**David Manteit V Brisbane City Council 2916/24**

Civil Works Engineers Report dated 28/3/25, pages 1-14.

**128 Ashridge Road, Darra QLD 4076**  
**Stormwater Technical Assessment**  
**(Applications: A006565555)**

This technical assessment has been prepared to support the formal request for the removal of Condition 18 and Condition 7, which requires the provision of upstream stormwater connections for Lots 98 and 99 RP29723 as well as the implications of easements associated as per the approved plans marked up by Council. Following a detailed review of the site conditions, natural drainage patterns, and Council's indicative sketch, it has been determined that this requirement is not feasible nor necessary. The following points outline the reasons why the upstream connection condition should be removed.

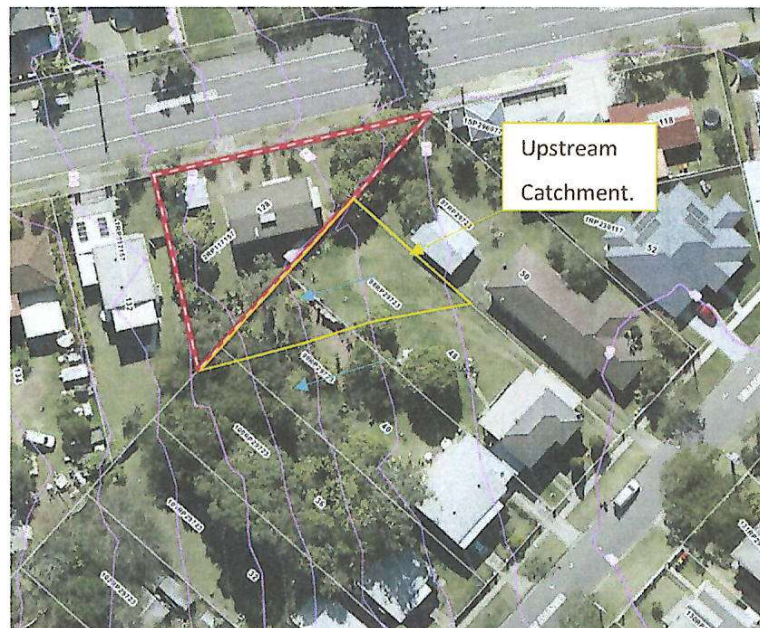
The existing topography of the upstream properties will first need to be considered prior to assessing the requirements for the provision of upstream property connections. Refer to diagram 1 for the existing contour plans obtained from Brisbane City Council's interactive mapping.

Based on the above diagram;

While it is understood that some portions of Lots 98 and 99 do drain towards the subject site, it is critical to note that all of Lot 2 naturally drains towards the downstream neighbouring property (Lot 1 RP117157). In addition to the above, over half of Lot 1 also drains towards the rear of the lot.

As such, any runoff from Lots 98 and 99 that does enter the subject site immediately continues to the downstream neighbouring properties rather than accumulating on site. This will imply that an upstream stormwater connection would serve no practical function as stormwater runoff already naturally drains downstream away from Ashridge Road.

With the above, it can be deduced that Council's request for upstream connections for Lots 98 and 99 are based on an assumed need rather than an assessment of the actual drainage patterns on site.

Diagram 2 : Stormwater schematic based on Council's approved sketch with minimum grades

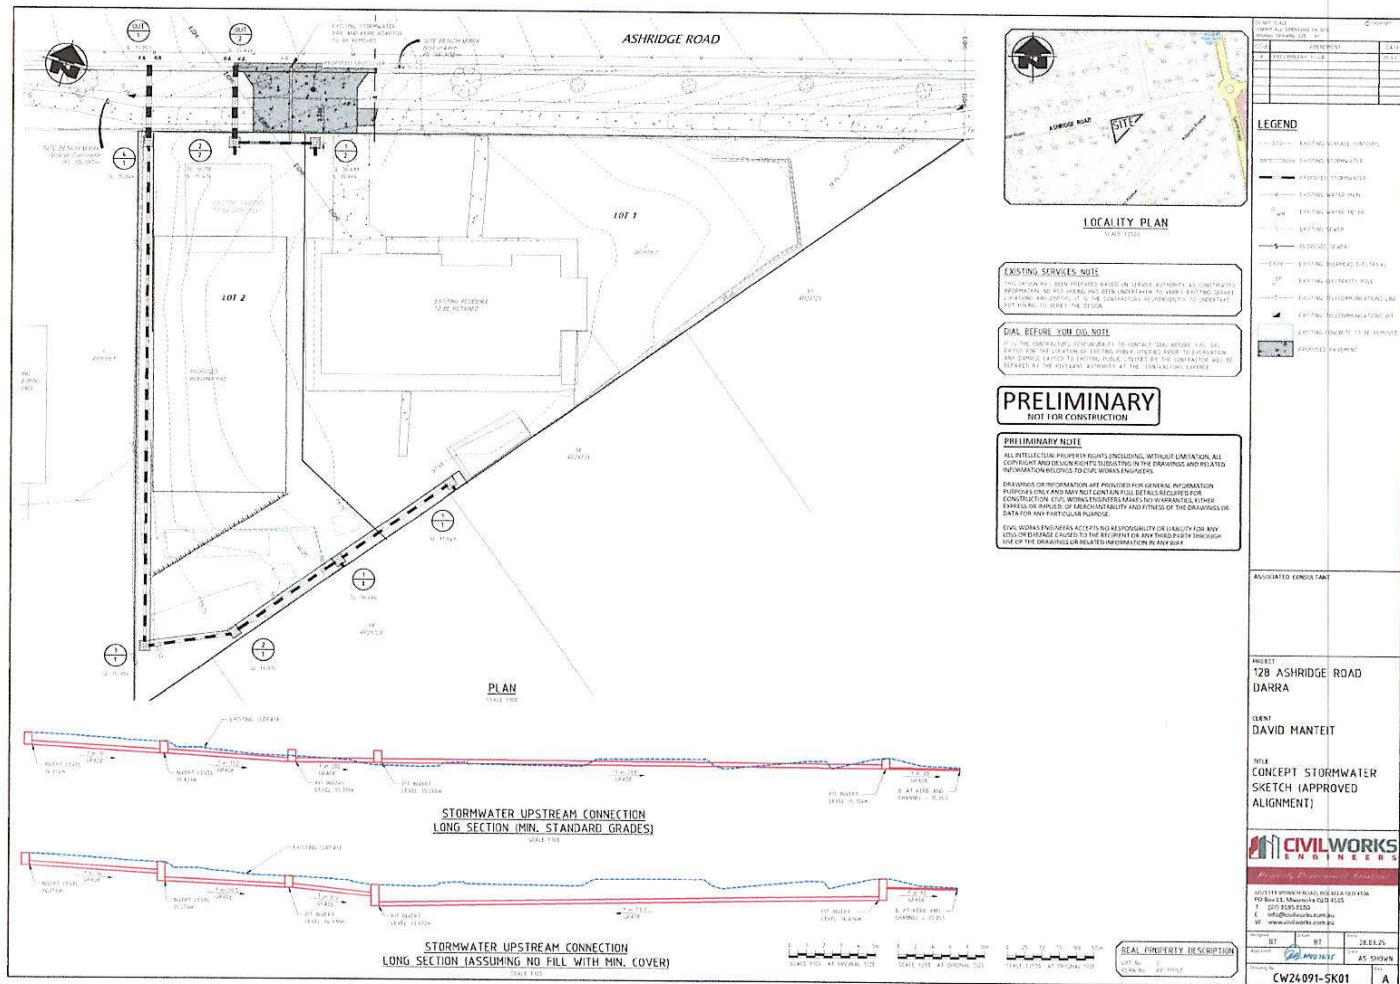
A detailed review of Council's indicative stormwater sketch, considering surface levels, invert levels, and grade constraints, confirms that installing an upstream stormwater pipe at the minimum grade would result in an exposed pipe for most of its length along the western side of Lot 2. Refer to diagram 2 obtained from attached concept sketch CW24091-SK01-REVA:

This is a fundamental engineering issue as an exposed stormwater pipe:

- Is structurally vulnerable.
- Would pose maintenance and safety concerns.
- Is not a standard or practical stormwater solution.

It will result in a charged system with an approximate drop of 1.181m between the internal network and the kerb outlet resulting in a charged system that would be inefficient.
